# Staff Report

Infill Housing Design Review Committee

File Number: 3-A-23-IH

**Location:** 117 E. Springdale Ave. **Parcel ID** 81 F S 025  
**Zoning:** RN-2 (Single-Family Residential Neighborhood)  
**District:** Oakwood/Lincoln Park Infill Housing Overlay District

**1 Site Plan**  
3/16" = 1'-0"

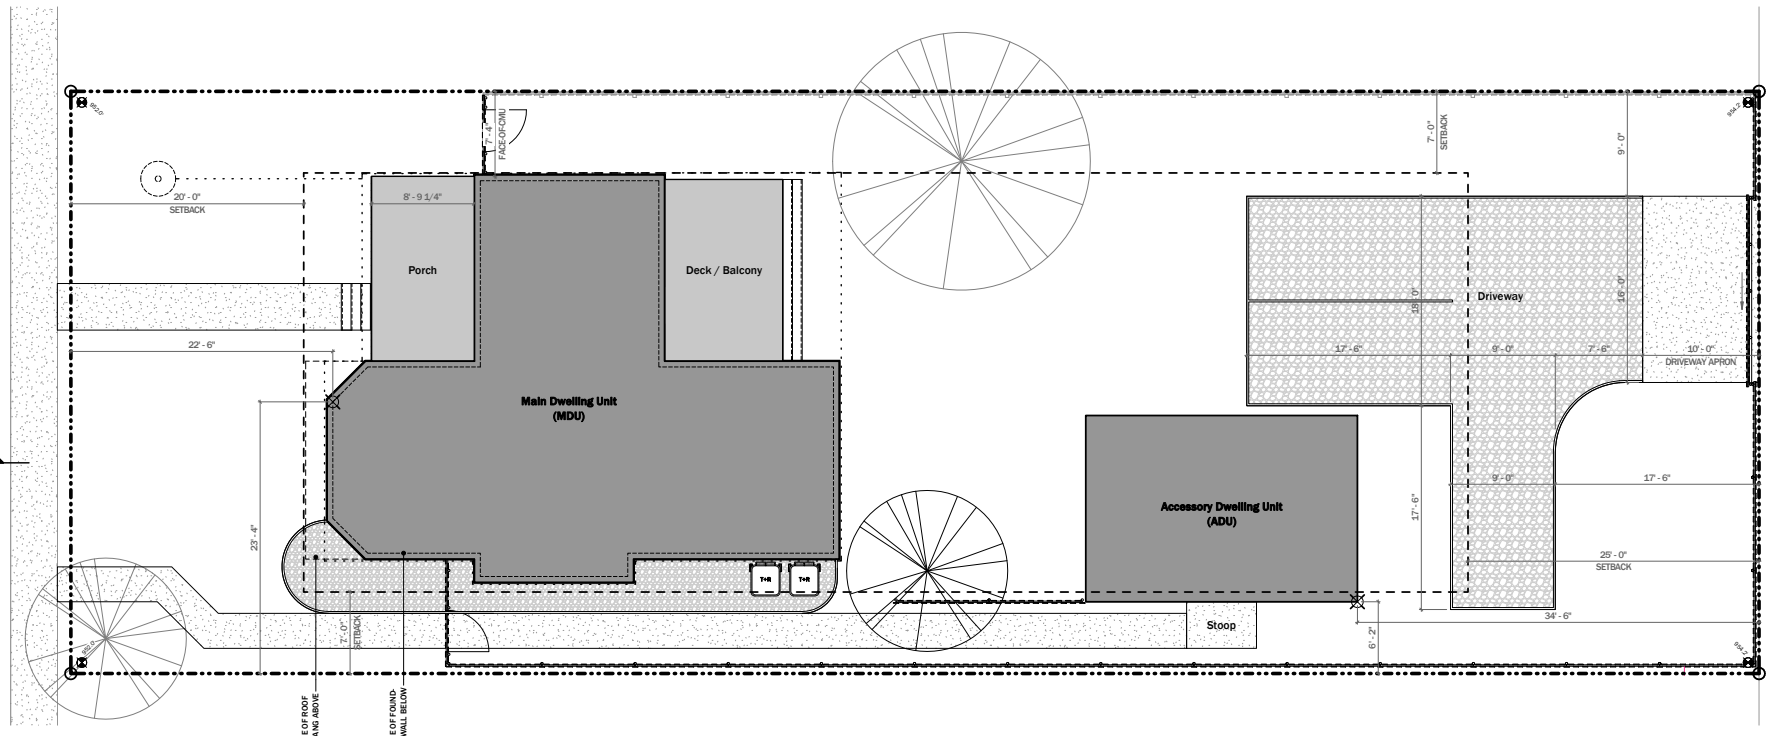
1. The new house will be set 22'-6" from the front property line. The average front setback of the block is 24', with adjacent houses set 22' and 19'. The front setback will maintain a consistent streetscape along the block. The site plan includes a walkway to the front sidewalk.

3. The proposed parking meets the Infill Housing design guidelines as located behind the main house and accessible from the alley. Final modifications may be necessary to meet City Engineering standards and the impervious surface limits of the RN-2 zoning.

9. The final site plan includes multiple new and existing shade trees.
10. The ADU meets the Infill Housing design guidelines for accessory structures, being placed behind the primary structure on the lot. The ADU is modest in size and scale and will be minimally visible from the primary street.

Staff recommends approval of Certificate 3-A-23-IH, subject to the following condition: 1) final site plan to meet City Engineering standards and remain within coverage limits of the RN-2 zoning.

**1 Front Elevation @ Southeast (MDU)**  
1/4" = 1'-0"

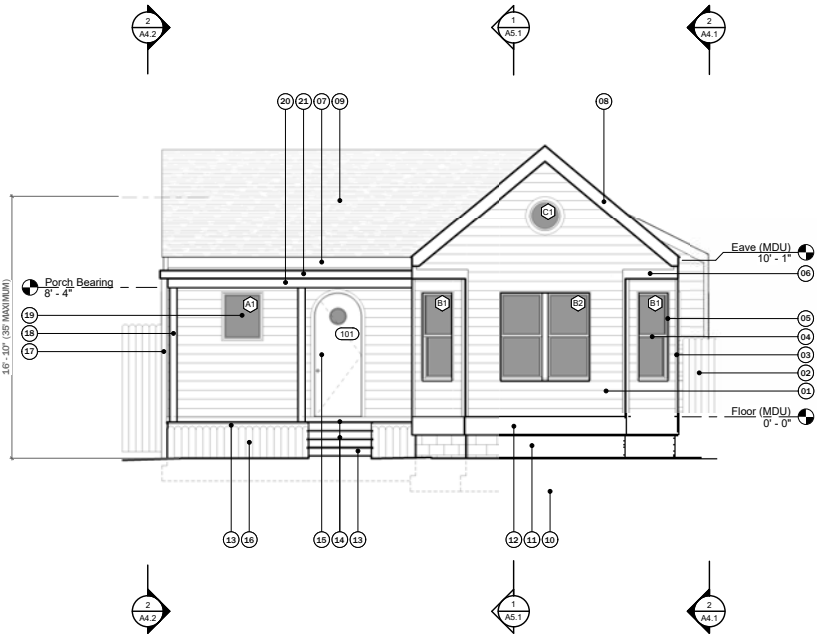
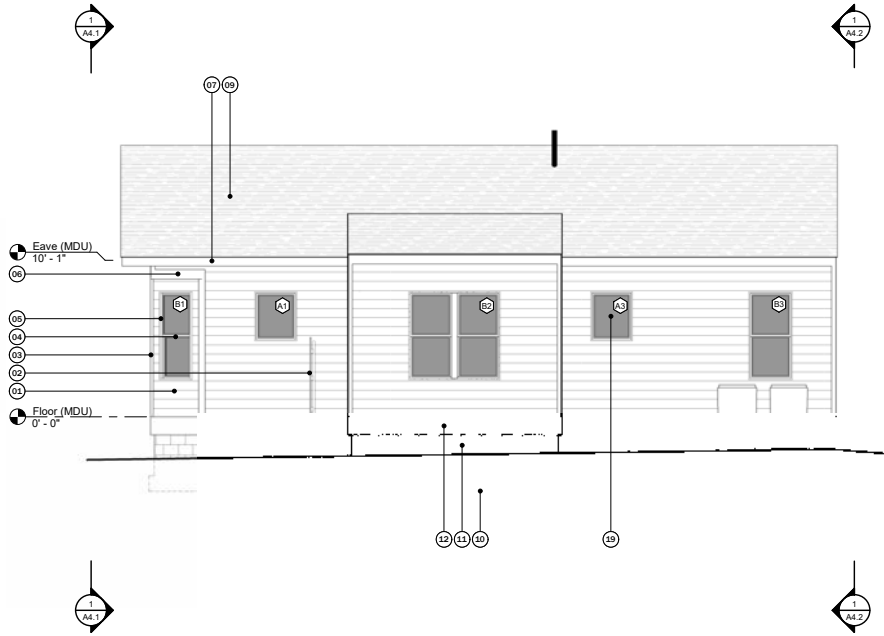
4. The façade is compatible in width and scale with original houses on the block. The overall design contains projecting bays and massing details compatible in scale with the context, and the foundation height reflects those on original houses in the neighborhood.

5. The design includes an 8' deep, partial-width porch on the left half of the façade.
6. The selected windows are similar in style to historic houses on the block. The façade demonstrates similar proportion and positioning to the context, and the side elevations demonstrate sufficient transparency.

7. The 10/12 roof pitch and complex rooflines are appropriate for the historic context.
8. The roof, siding, and foundation materials meet the design guidelines.
